SERVICE BULLETIN

N° **139-694**

ATA 56 – WINDOW GASKET UPGRADE

This Service Bulletin is issued in order to provide the necessary instructions to introduce a new gasket installation on the basic jettisonable emergency exit of the helicopter .

Figure 19

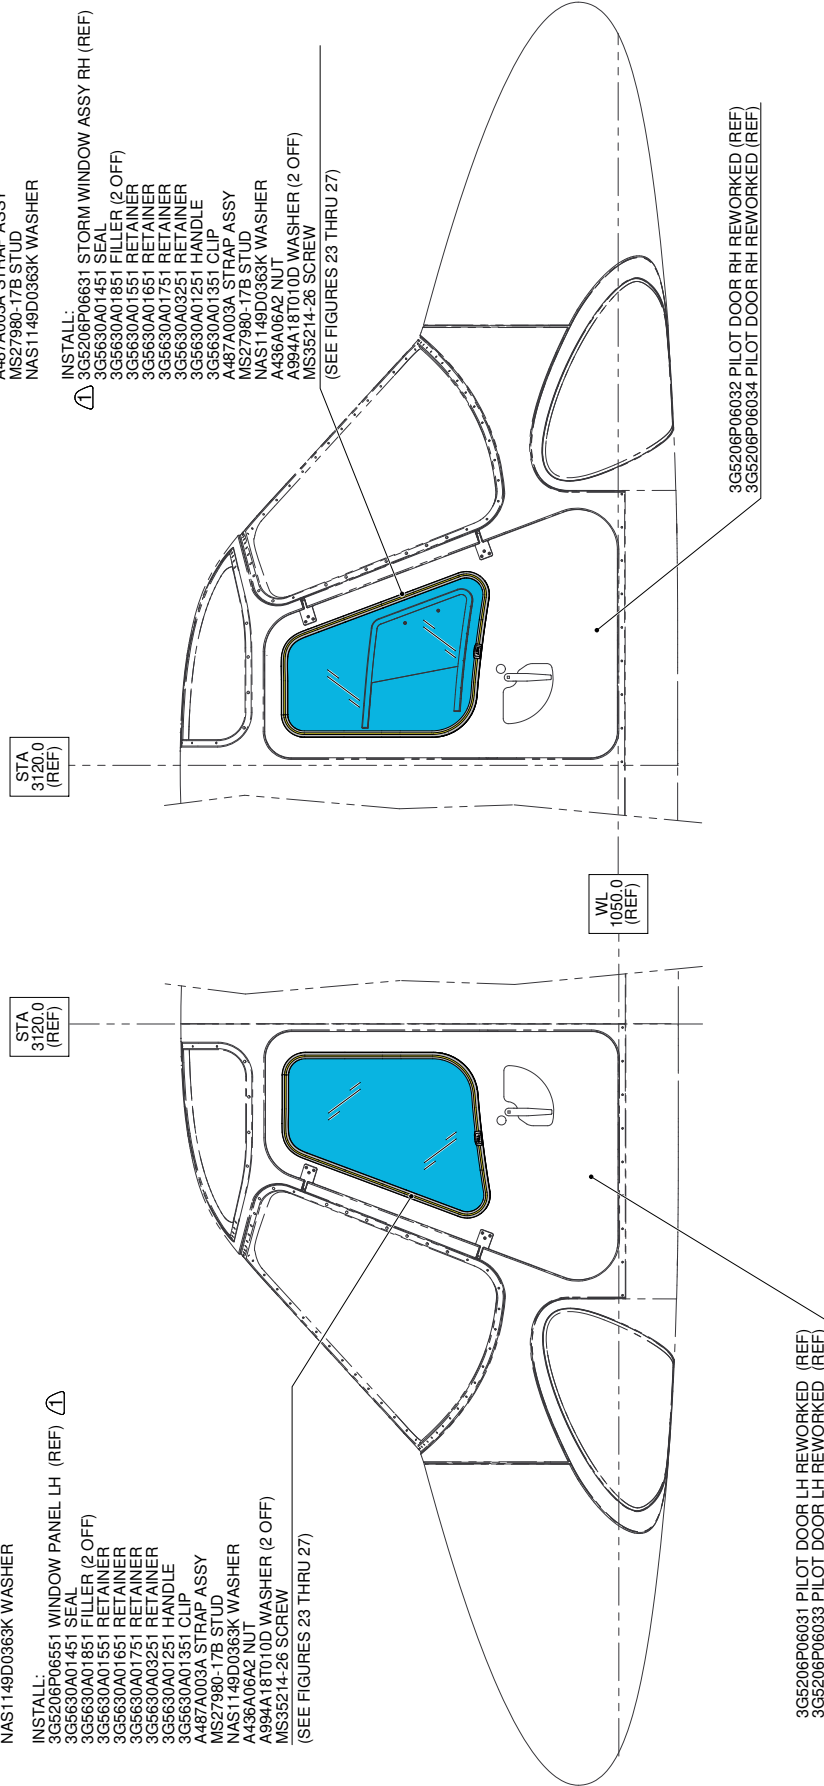
- REMOVE:**
- 3G5206P06551 WINDOW PANEL LH REWORKED (REF)
 - 999-1700-48-101G SEAL
 - 999-1700-49-101G FILLER
 - 3G5610A04751 STRAP
 - A436A06A2 NUT
 - A994A18T010D WASHER (2 OFF)
 - MS35214-26 SCREW
 - A487A003A STRAP ASSY
 - MS27980-17B STUD
 - NAS1149D0363K WASHER

- INSTALL:**
- 3G5206P06551 WINDOW PANEL LH (REF) (A)
 - 3G5630A01451 SEAL
 - 3G5630A01851 FILLER (2 OFF)
 - 3G5630A01551 RETAINER
 - 3G5630A01651 RETAINER
 - 3G5630A01751 RETAINER
 - 3G5630A03251 RETAINER
 - 3G5630A01251 HANDLE
 - 3G5630A01351 CLIP
 - A487A003A STRAP ASSY
 - MS27980-17B STUD
 - NAS1149D0363K WASHER
 - A436A06A2 NUT
 - A994A18T010D WASHER (2 OFF)
 - MS35214-26 SCREW
- (SEE FIGURES 23 THRU 27)

- REMOVE:**
- (A) 3G5206P06631 STORM WINDOW ASSY RH
 - 999-1700-48-101G SEAL
 - 999-1700-49-101G FILLER
 - 3G5610A04751 STRAP
 - A436A06A2 NUT
 - A994A18T010D WASHER (2 OFF)
 - MS35214-26 SCREW
 - A487A003A STRAP ASSY
 - MS27980-17B STUD
 - NAS1149D0363K WASHER

Figure 20

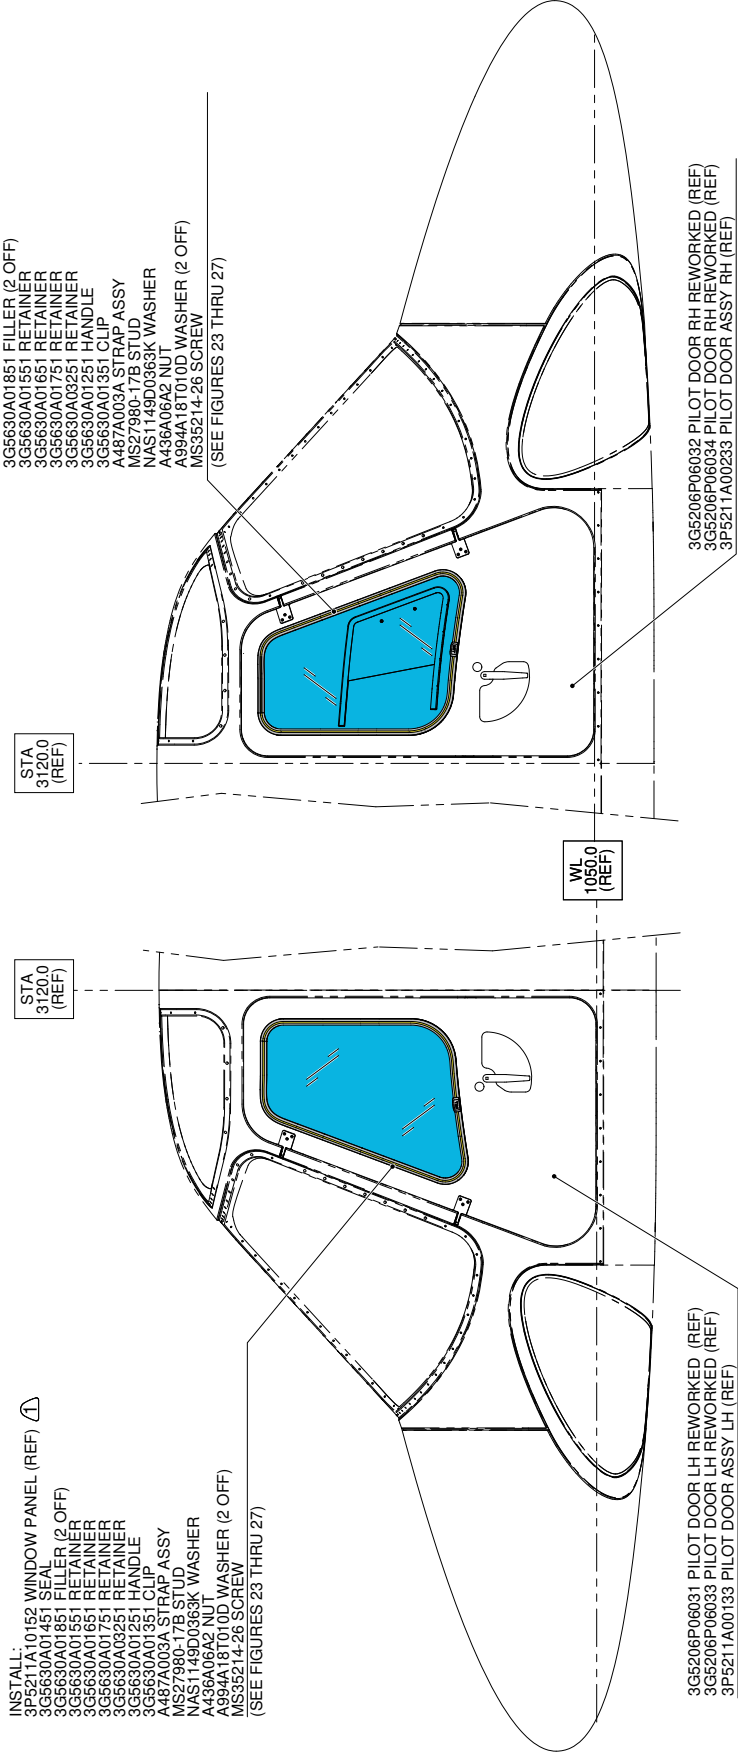
REMOVE:
 3P5211A48131 STORM WINDOW ASSY RH
 999-1700-48-101G SEAL
 999-1700-49-101G FILLER
 3G5610A04751 STRAP
 A436A06A2 NUT
 A994A18T010D WASHER (2 OFF)
 MS35214-26 SCREW
 A487A003A STRAP ASSY
 MS27980-17B STUD
 NAS1149D0363K WASHER

REMOVE:
 3P5211A10152 WINDOW PANEL ⚠
 999-1700-48-101G SEAL
 999-1700-49-101G FILLER
 3G5610A04751 STRAP
 A436A06A2 NUT
 A994A18T010D WASHER (2 OFF)
 MS35214-26 SCREW
 A487A003A STRAP ASSY
 MS27980-17B STUD
 NAS1149D0363K WASHER

Figure 21

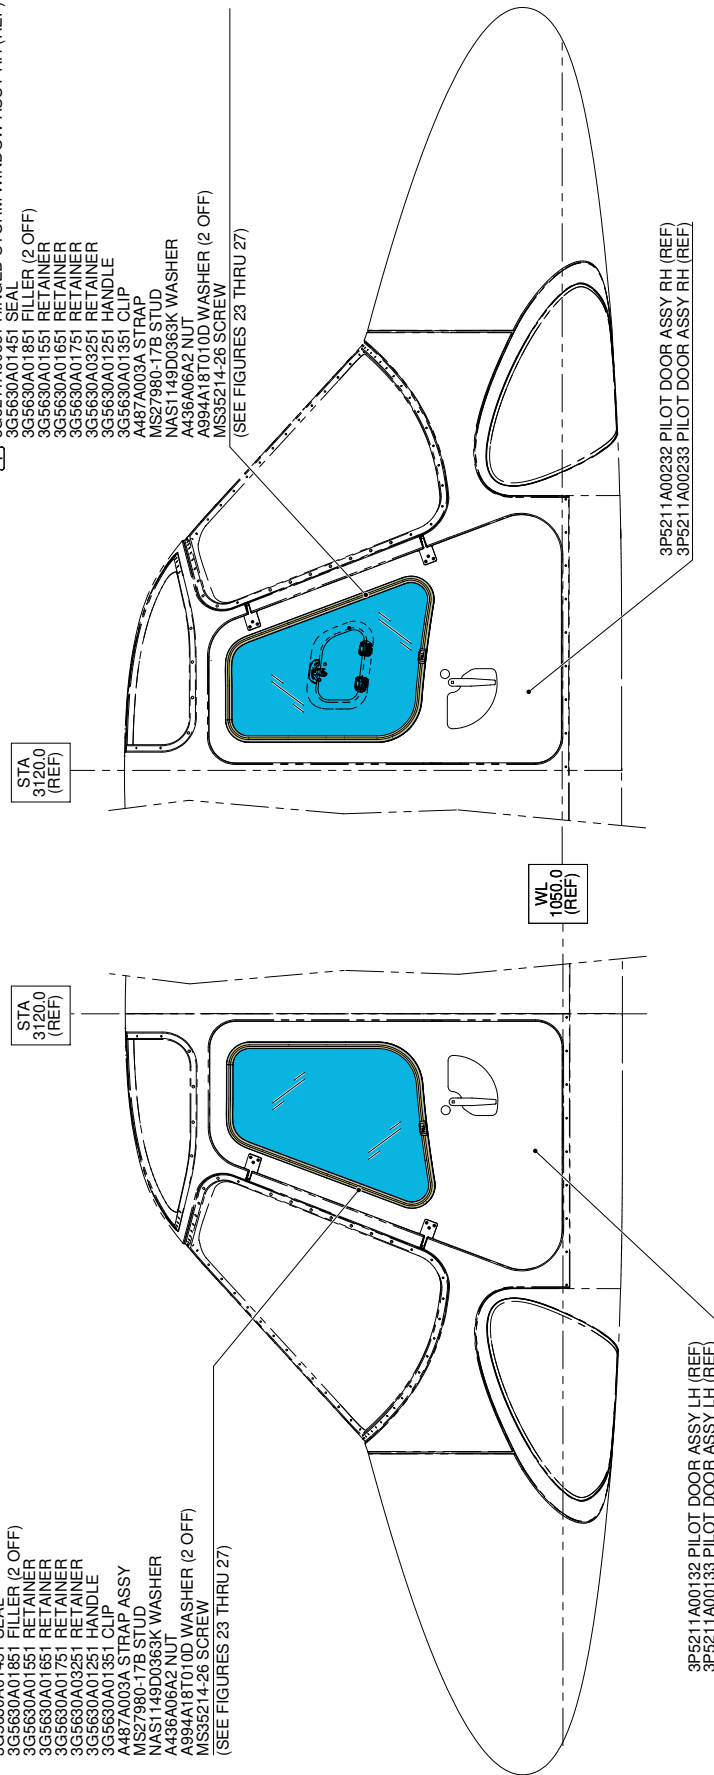
REMOVE:
 3G5211A01351 WINDOW PANEL LH (REF) (1)
 999-1700-48-101G SEAL
 999-1700-49-101G FILLER
 3G5610A04751 STRAP
 A436A06A2 NUT
 A994A18T010D WASHER (2 OFF)
 MS35214-26 SCREW
 A487A003A STRAP ASSY
 MS27980-17B STUD
 NAS1149D0363K WASHER

REMOVE:
 3G5211A00831 HINGED STORM WINDOW ASSY RH
 999-1700-48-101G SEAL
 999-1700-49-101G FILLER
 3G5610A04751 STRAP
 A436A06A2 NUT
 A994A18T010D WASHER (2 OFF)
 MS35214-26 SCREW
 A487A003A STRAP ASSY
 MS27980-17B STUD
 NAS1149D0363K WASHER

Figure 22

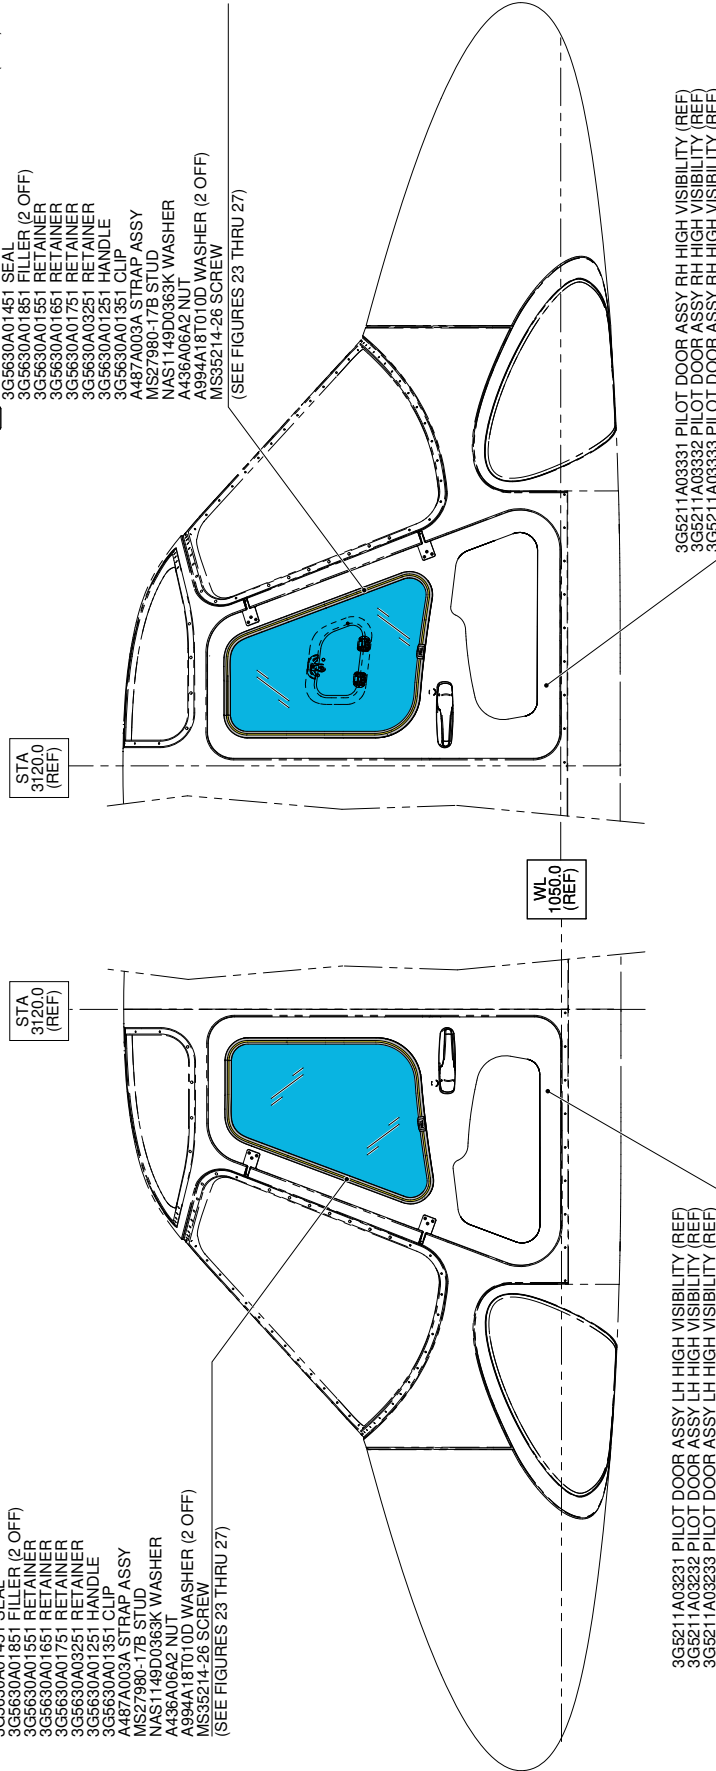
REMOVE:
 3G5211A01351 WINDOW PANEL LH (REF) ⚠
 999-1700-48-101G SEAL
 999-1700-49-101G FILLER
 3G5610A04751 STRAP
 A436A06A2 NUT
 A994A18T010D WASHER (2 OFF)
 MS35214-26 SCREW
 A487A003A STRAP ASSY
 MS27980-17B STUD
 NAS1149D0363K WASHER

REMOVE:
 3G5211A00832 STORM WINDOW ASSY RH
 999-1700-48-101G SEAL
 999-1700-49-101G FILLER
 3G5610A04751 STRAP
 A436A06A2 NUT
 A994A18T010D WASHER (2 OFF)
 MS35214-26 SCREW
 A487A003A STRAP ASSY
 MS27980-17B STUD
 NAS1149D0363K WASHER

Figure 24

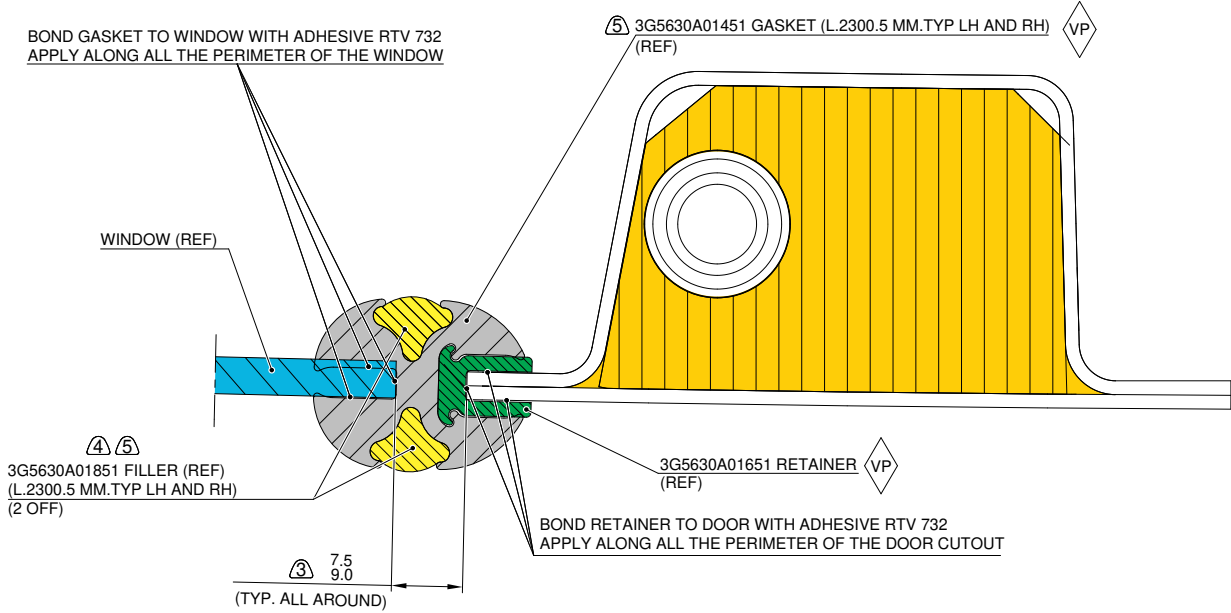
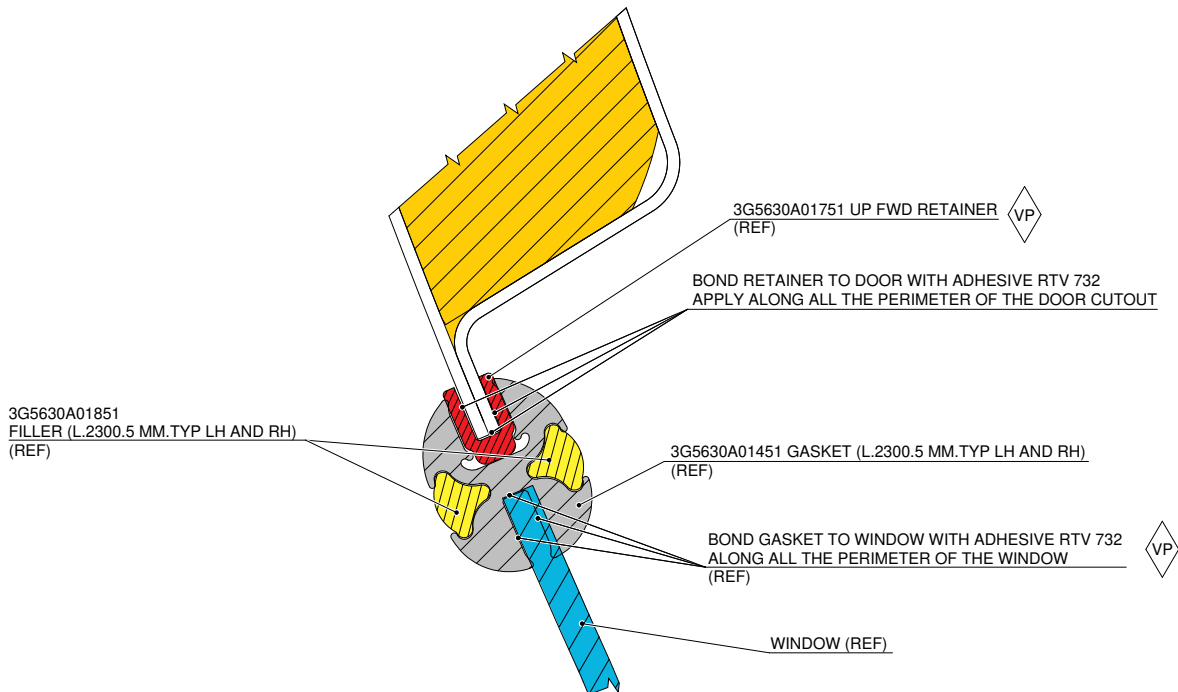
- ③ CHECK INSTALLATION DIMENSION, NO REWORKING ALLOWED.
- ④ ON INTERNAL FUSELAGE SIDE INSTALL FILLER STARTING FROM TOP SIDE OF FRAME WINDOW.
- ⑤ ON EXTERNAL FUSELAGE SIDE:
-INSTALL FILLER STARTING FROM TOP SIDE OF FRAME WINDOW;
-CHECK IF THERE IS SQUEEZE OUT OF ADHESIVE ALL AROUND THE GASKET, IF NOT, LIFT THE SEAL EDGE AND FILL AGAIN.

Figure 25

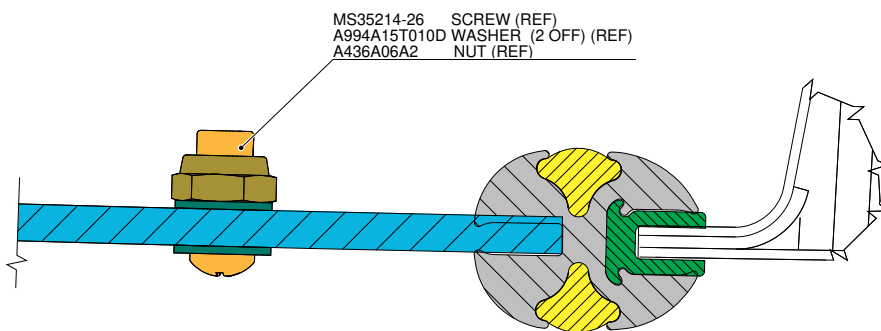
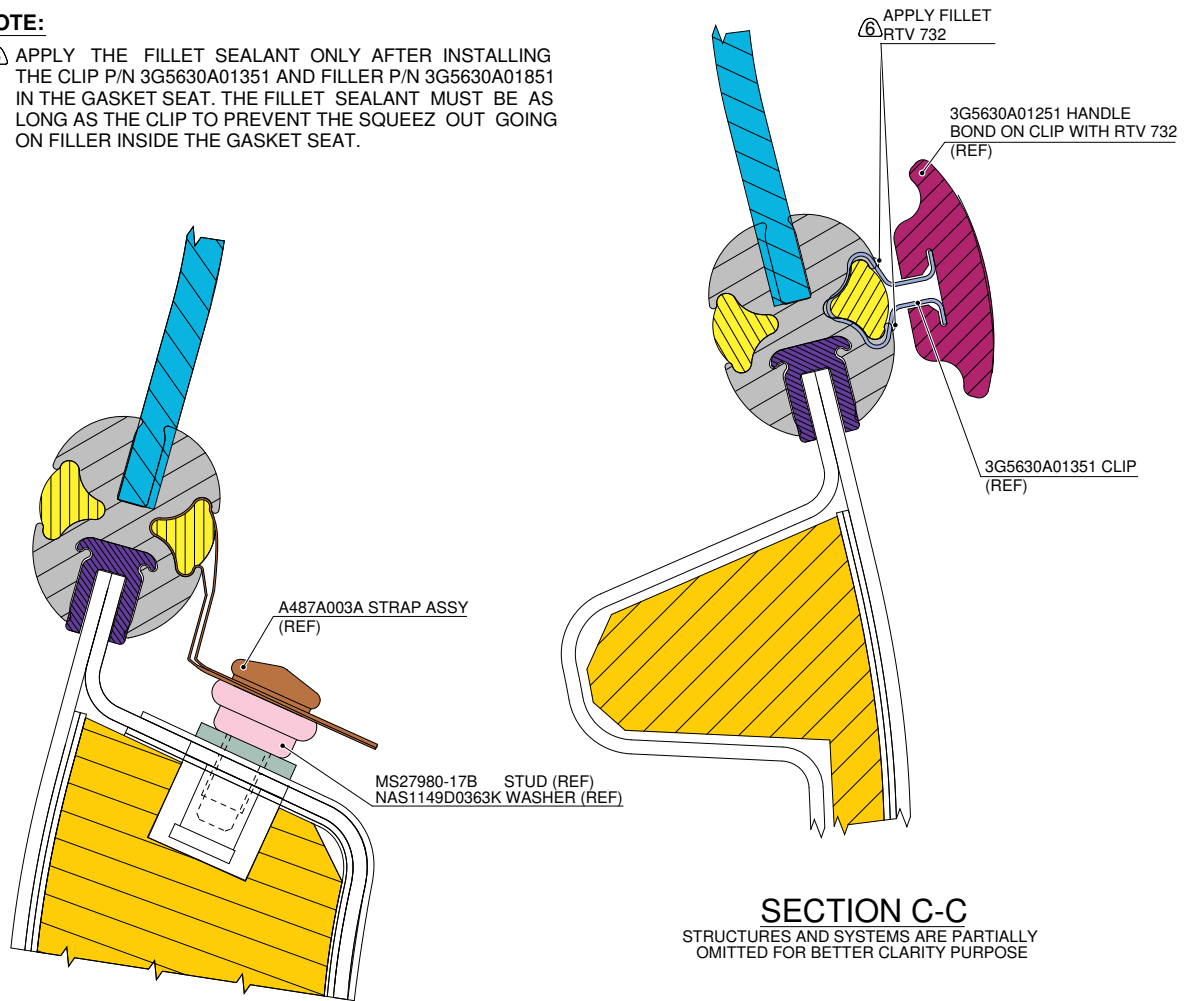
- ⑥ APPLY THE FILLET SEALANT ONLY AFTER INSTALLING THE CLIP P/N 3G5630A01351 AND FILLER P/N 3G5630A01851 IN THE GASKET SEAT. THE FILLET SEALANT MUST BE AS LONG AS THE CLIP TO PREVENT THE SQUEEZ OUT GOING ON FILLER INSIDE THE GASKET SEAT.

Figure 30

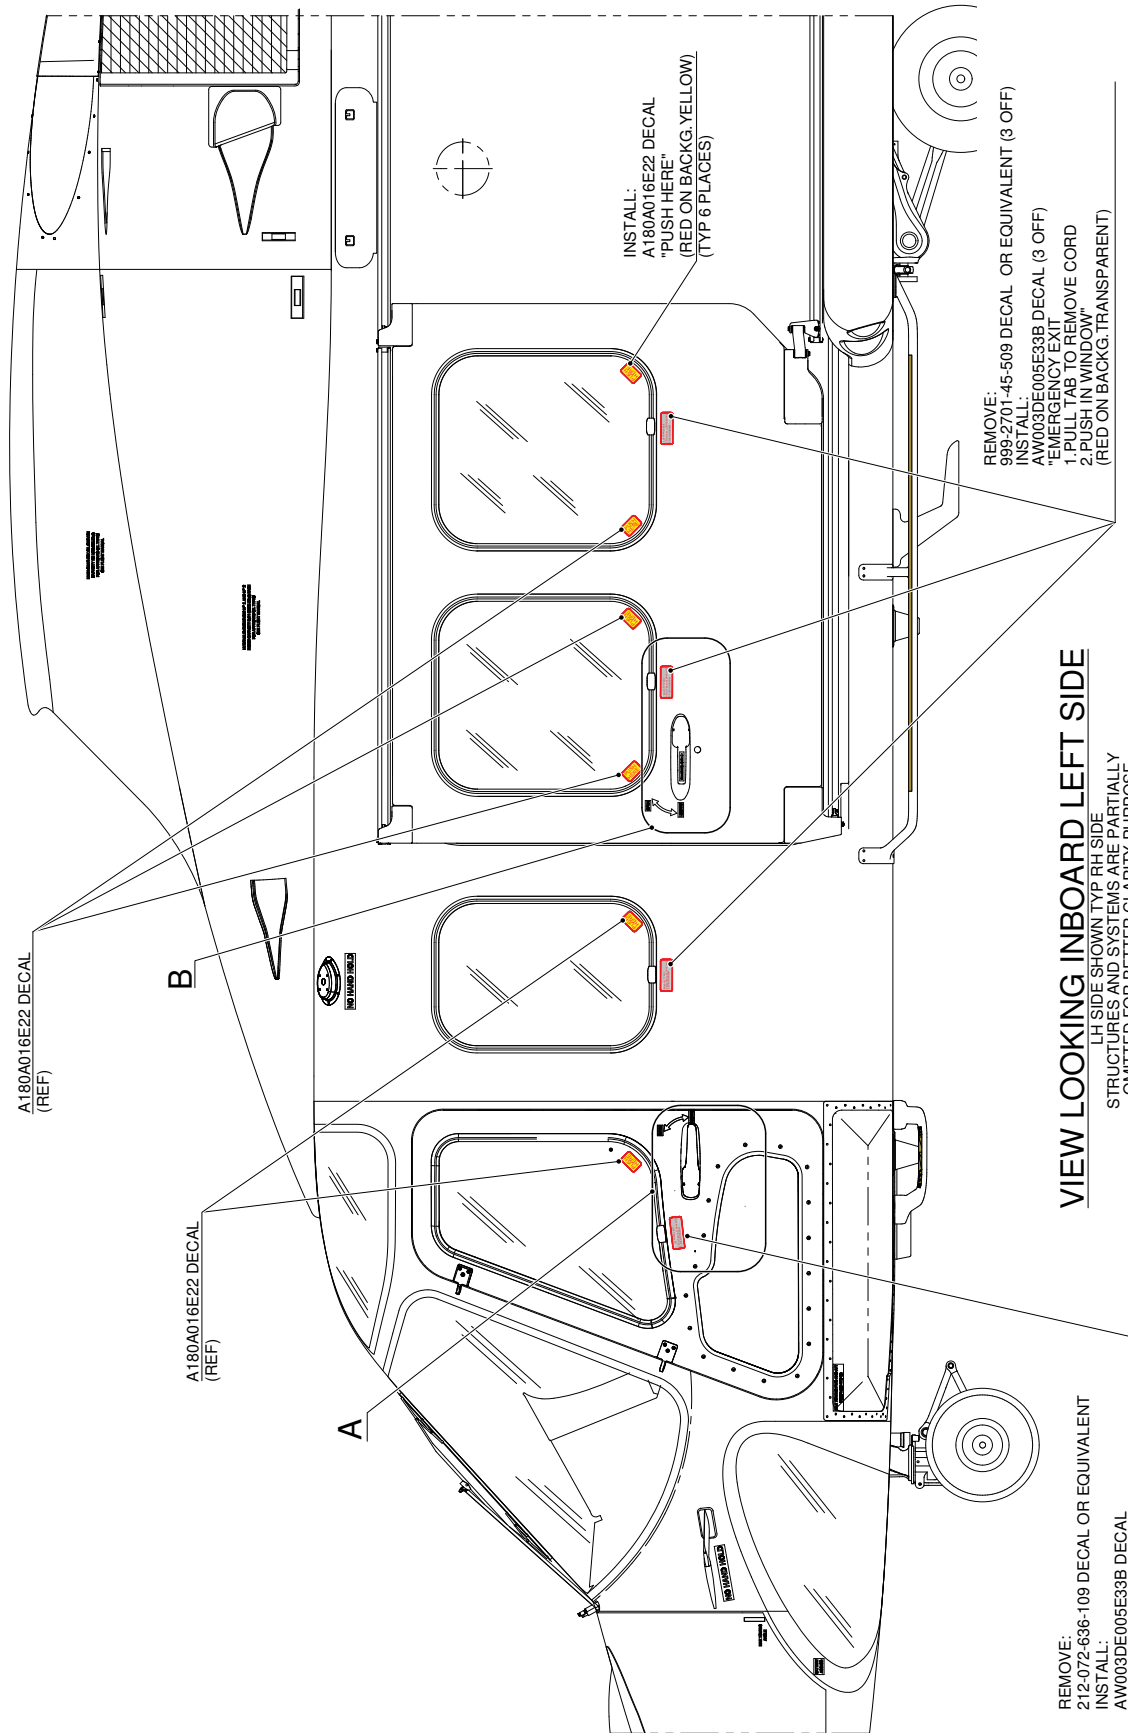
3. In accordance with the applicable steps of AMP DM 39-A-11-00-01-00A-520A-A and with reference to Figure 30, remove the following decals from the left outer side of the helicopter:
